**REGULAR MEETING OF THE THIRD LAGUNA HILLS MUTUAL  
ARCHITECTURAL CONTROL AND STANDARDS COMMITTEE**

**Thursday, January 18, 2018 – 9:30 a.m.  
Laguna Woods Village Community Center Sycamore Room  
24351 El Toro Road**

**DATE:** January 18, 2018  
**FOR:** Architectural Control and Standards Committee  
**SUBJECT:** Variance Request  
Mr. Rodolfo Alvarez of 3064-A (San Clemente, OO03\_2)  
Window Modifications to Kitchen and Bedroom

**DATE:** January 17, 2018  
**FOR:** Architectural Control and Standards Committee  
**SUBJECT:** Variance Request  
Ms. Sondra Baren of 3386-C (Andaluz, P203RA)  
Retain Non-Standard Front Entry Door Color

EXISTING WINDOW ELEVATION #1  
KITCHEN WINDOW

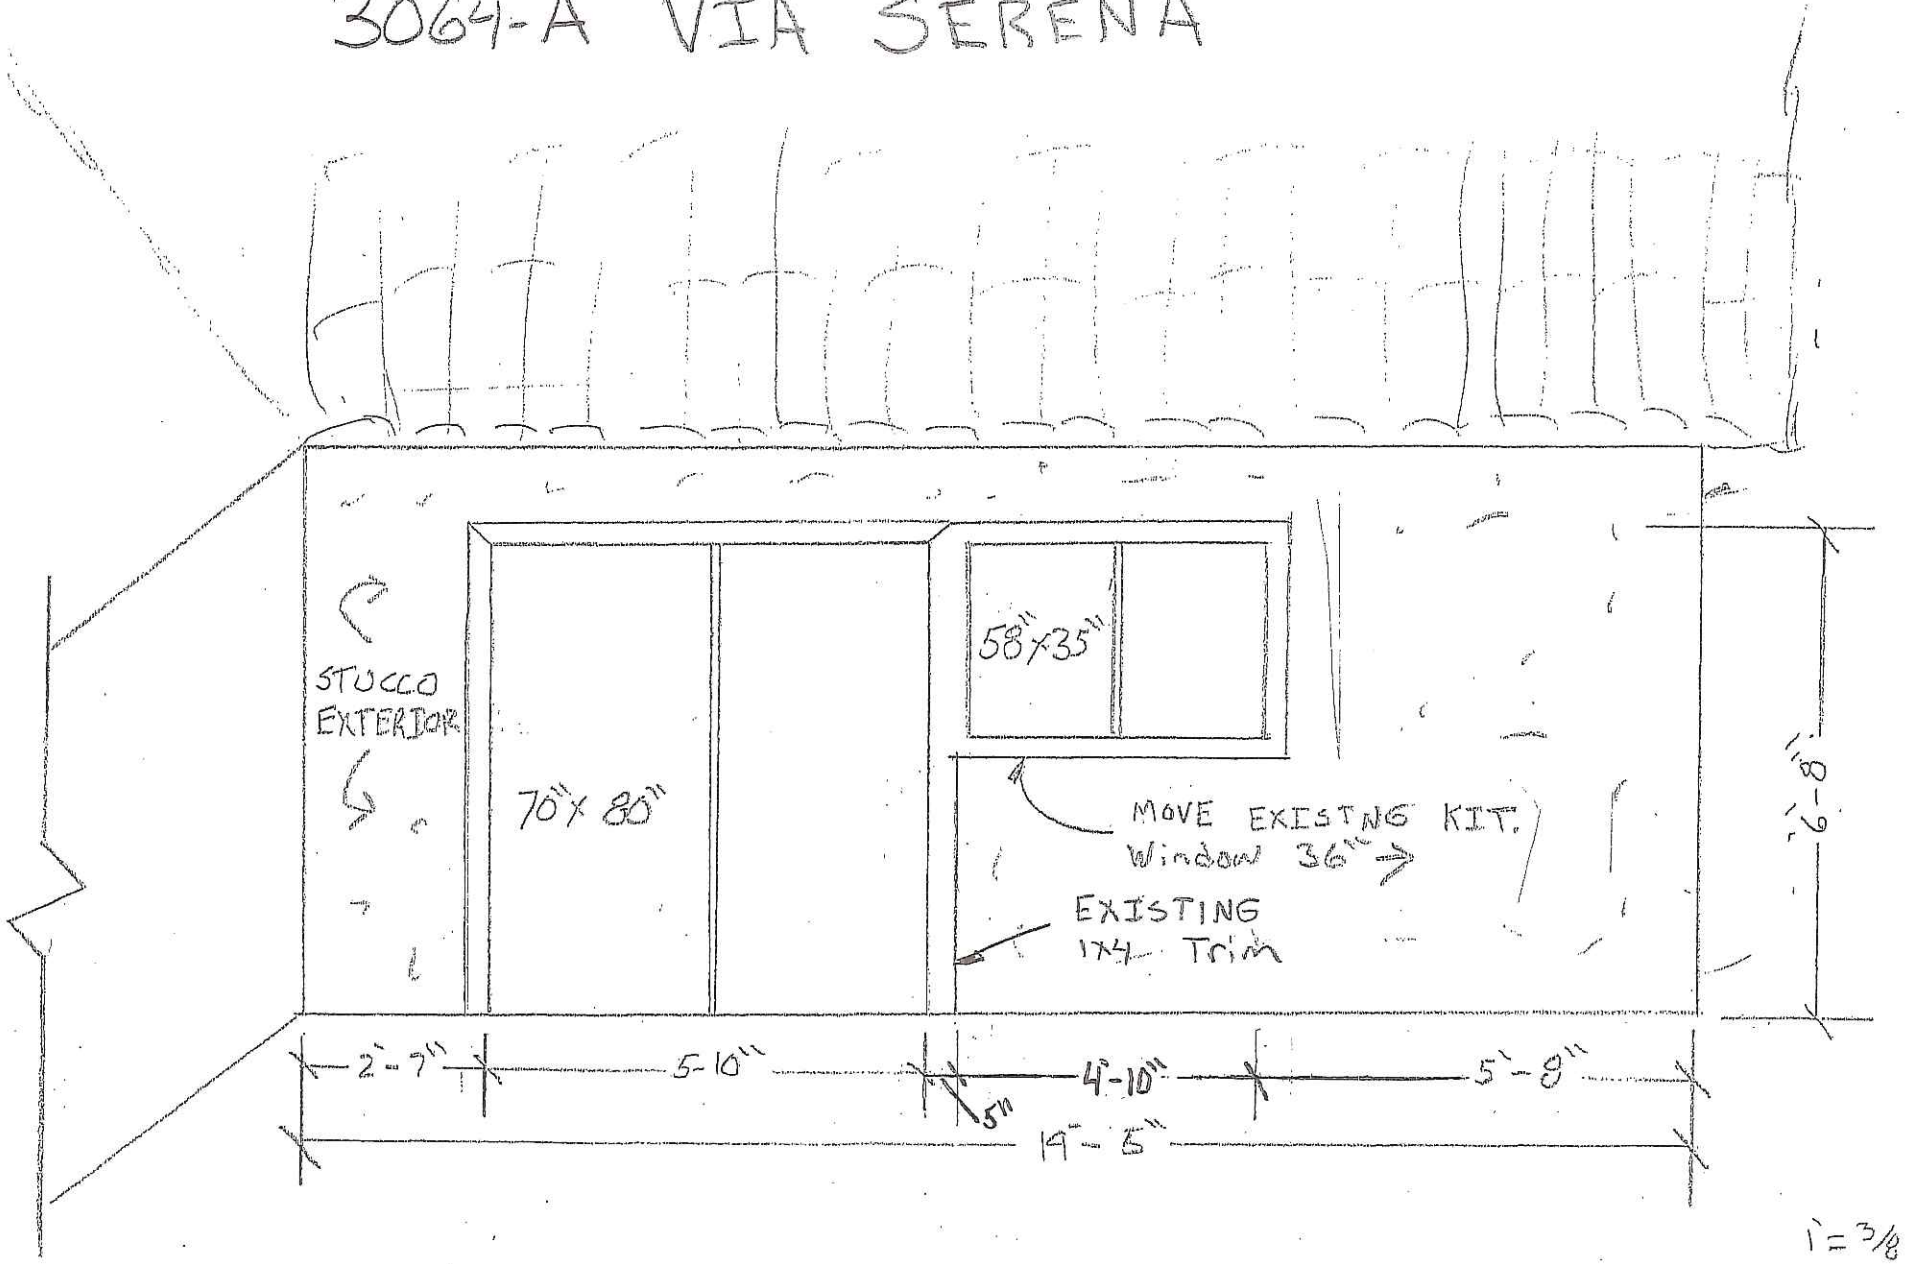
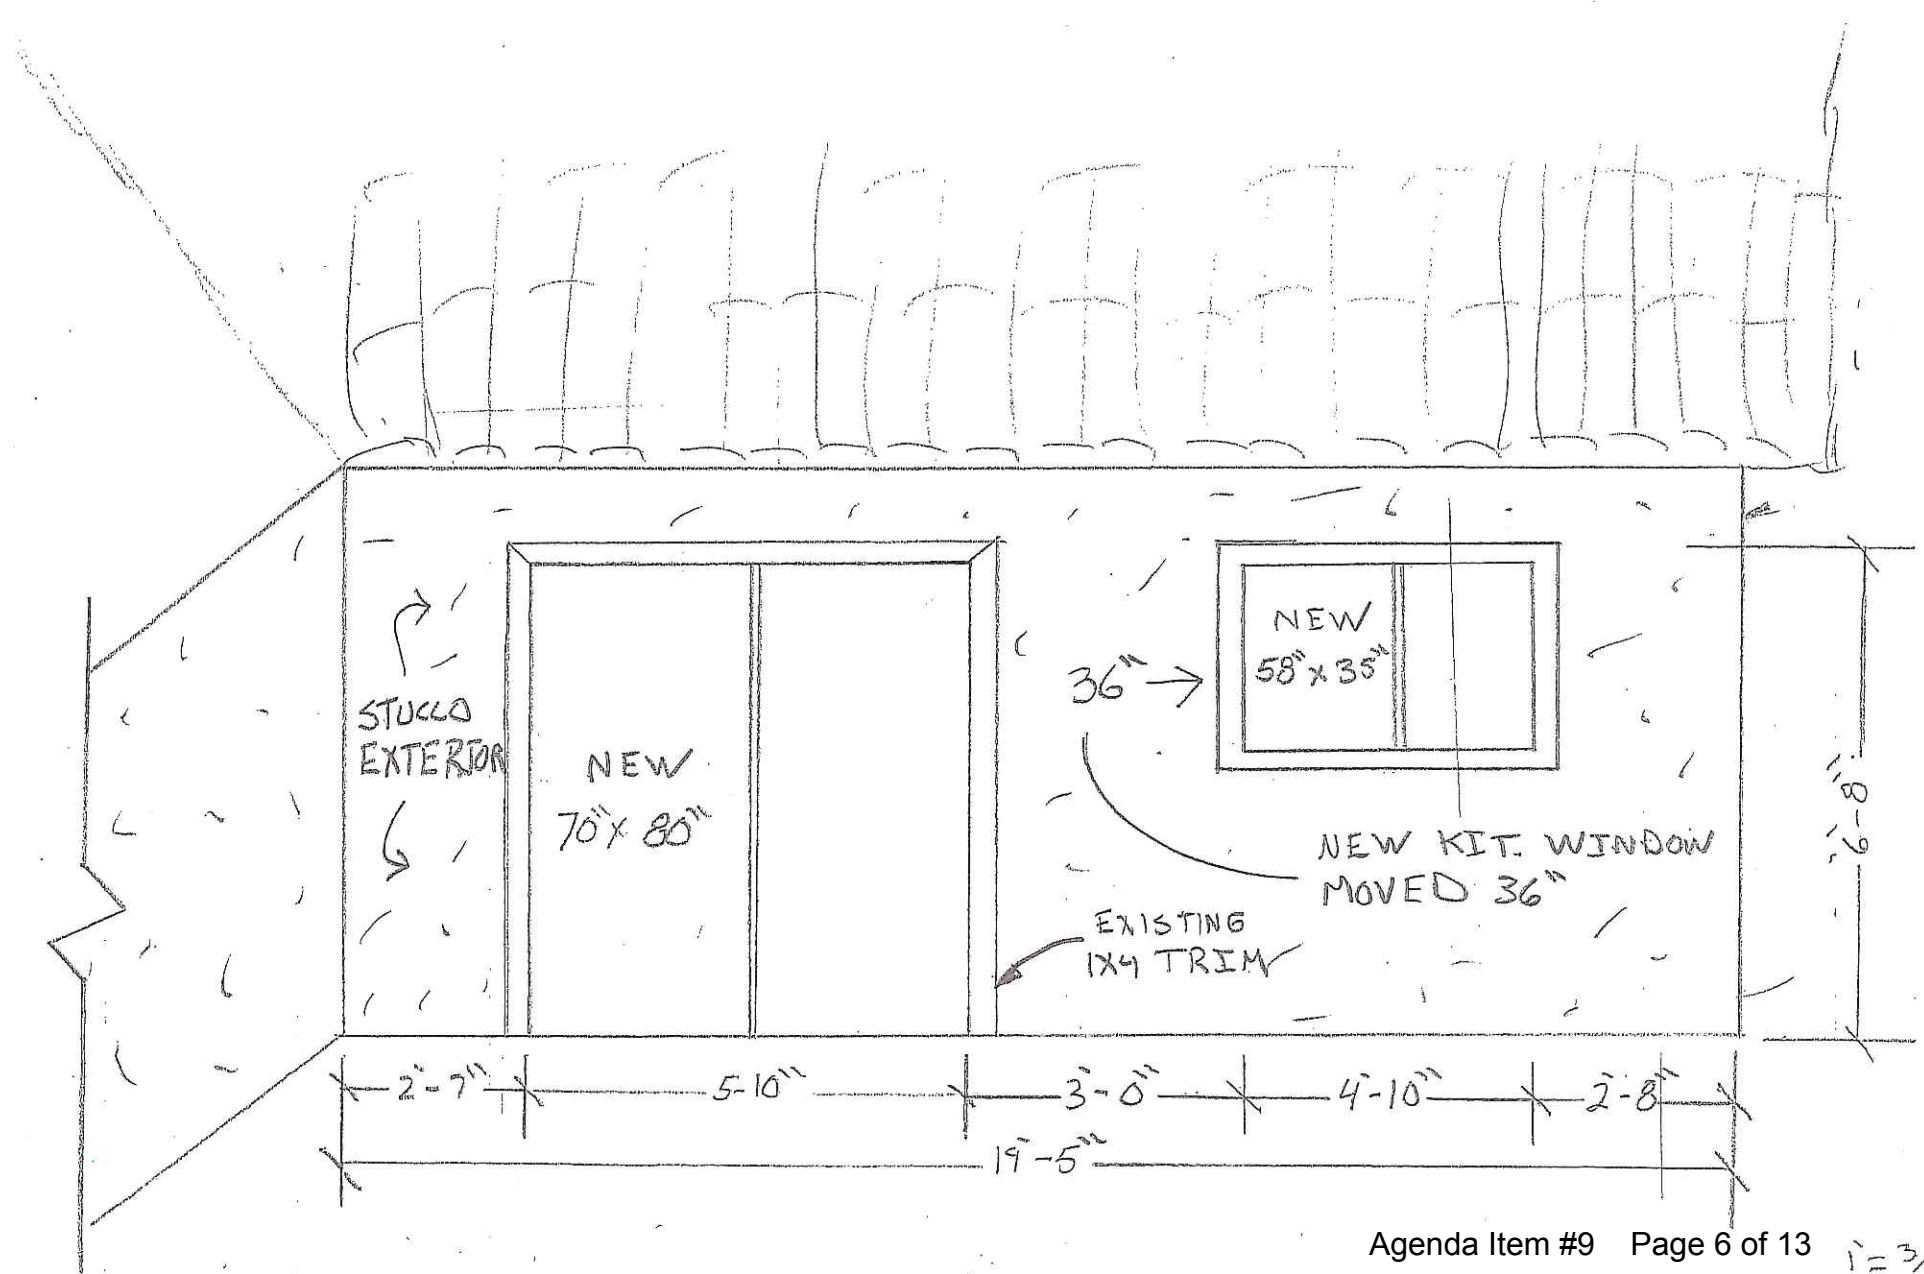
Mr. Alvarez is proposing to relocate the existing four foot, ten inch wide by three foot tall kitchen window away from the sliding glass door by thirty-six inches. The existing head and sill height of the window would remain the same as existing, while white vinyl will be used to meet the existing Mutual Standards for windows. The San Clemente floor plan is a U-shaped building where all kitchen windows and doors face into a courtyard. In order to maintain consistency of the buildings' appearance, Staff recommends denying the relocation request.

Staff recommends the Board deny the request for a window relocation in kitchen and to approve the request to relocate a bedroom window with the conditions as stated in Appendix A.
